U.S. Department
of Transportation
**Federal Highway
Administration**

REFER TO:
HNG-14

In your October 3 letter to Mr. Thomas O. Willett you requested FHWA acceptance for use on Federal-aid projects of several fiberglass luminaire support poles manufactured by your company. This request was submitted subsequent to our June 15, 1988, acceptance of Sherman International Pole MB36-D-50-S6. Your current request is that the test results for that pole be extrapolated to indicate acceptable performance of the 62 poles listed in the attachment to your letter.

Your March 18 letter to Mr. Willett requesting acceptance for use on Federal-aid projects of a fiberglass pole manufactured by your company and the supplemental information you forwarded in April and in June has been reviewed. In support of this request, you submitted a copy of a report detailing the full-scale crash testing that was conducted. The report, FHWA/RD-87-065, Fiberglass Luminaire Supports, was prepared by Mobility Systems and Equipment Company under Contract No. DTFH61-86-Z-00073. You also submitted information on the mechanical properties of spun fiberglass reinforced plastic (FRP) laminate, a description of the spun p

FEDERAL HW 11.1 M.	
CAT. NO. MB35-D-50-S6	WIND VEL. 100 @ 1.3
QUANTITY: _____	TOT. LENGTH 34'-5"
JOB NUMBER: _____	LUM. WEIGHT 50 LBS
PO. NUMBER: _____	EMBED. DEPTH 5'-0"
APPD BY: <i>FHW 6/9/88</i>	TIP DIA. 4.41"
REV. DATE BY REMARKS	TOT. DEFL. 15.3 X
_____	WEIGHT 136.7 LBS.
_____	BY RUNDLE 6-8-88

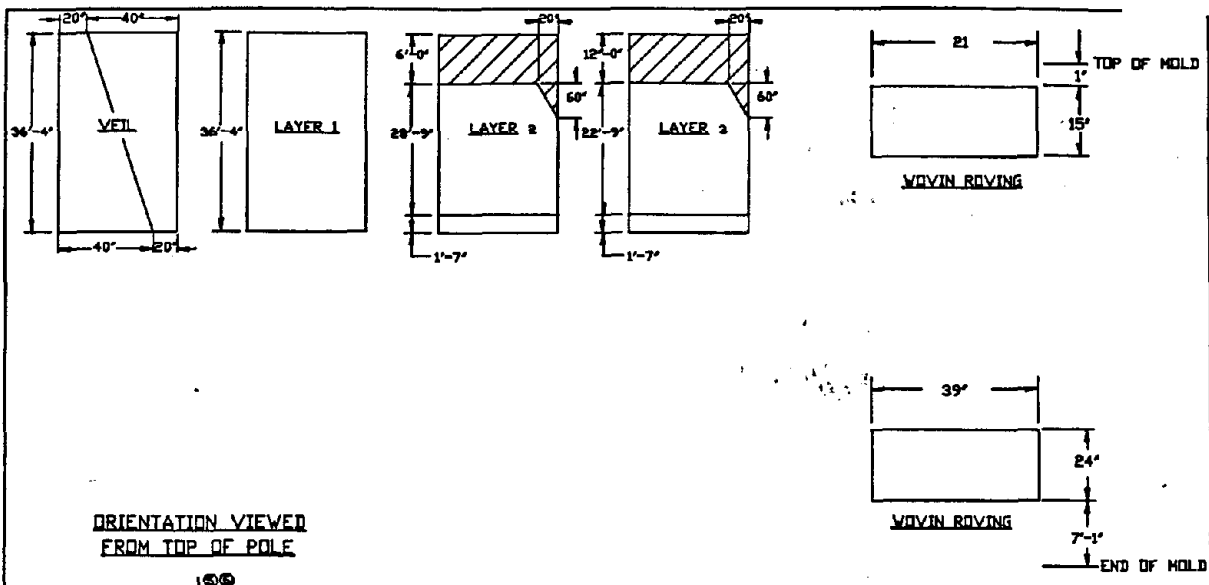
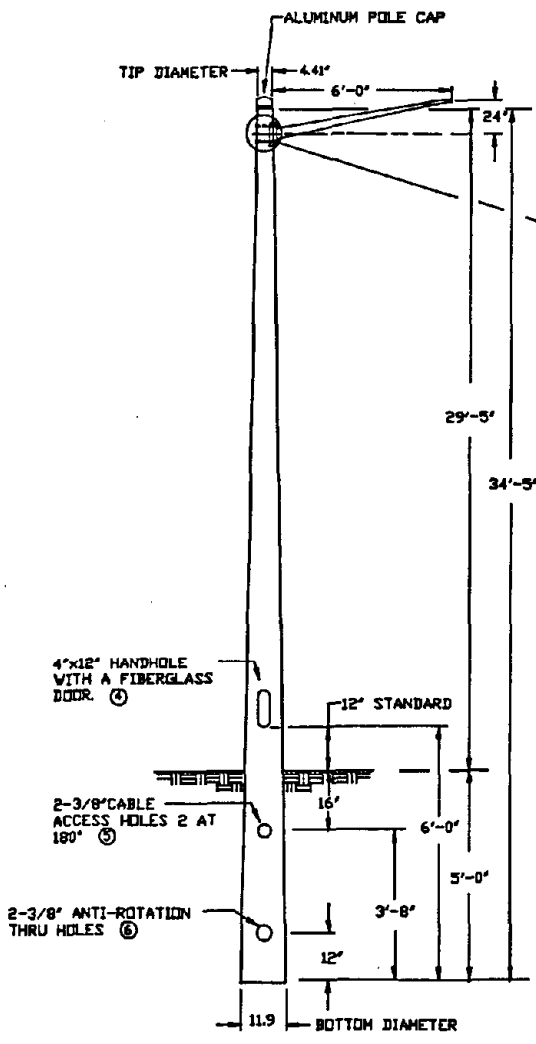
Two identical test poles were impacted by 1,800-pound Volkswagen Rabbits at 20 and 60 m.p.h. The tested poles are currently catalogued as MB 36-D-50-56, but were identified as XHD112-105-H at the time the testing was done. They each had a total length of 34 feet, 5 inches and were embedded 5 feet into the ground in an S-1 (strong) soil. Their diameters decreased from 10.6 inches at the ground line to 4.4 inches at the top. Their wall thicknesses varied from .38 inches at ground line to .13 inches at the top. The total weight of each tested installation, including a 6-foot mast arm with a 50-pound weight, was 193 pounds.

In the 20 m.p.h. test, the longitudinal occupant impact velocity was 14.4 feet per second, slightly below the 15 feet per second maximum suggested in NCHRP Report 230. The 60 m.p.h. test resulted in a vehicular change in velocity of 10.3 feet per second, very near the desirable change in velocity of 10 feet per second recommended in the 1985 AASHTO Standard Specifications for Structural Supports for Highway Signs, Luminaires and Traffic Signals. It is noted, however, that, in the high speed test, the pole impacted the roof of the vehicle before it broke away, resulting in deformation of the passenger compartment. This gives us some concern, but we consider the degree of occupant compartment intrusion to be acceptable.

Therefore, based on the information in the test report, we concur that your fiberglass pole MB 36-D-50-56 (previously XHD112 - 105-H) meets current FHWA breakaway requirements and those in the 1985 AASHTO Standard Specifications for Structural Supports for Highway Signs, Luminaires, and Traffic Signals. Thus, it will be acceptable for use on Federal-aid projects if proposed by a State highway agency.
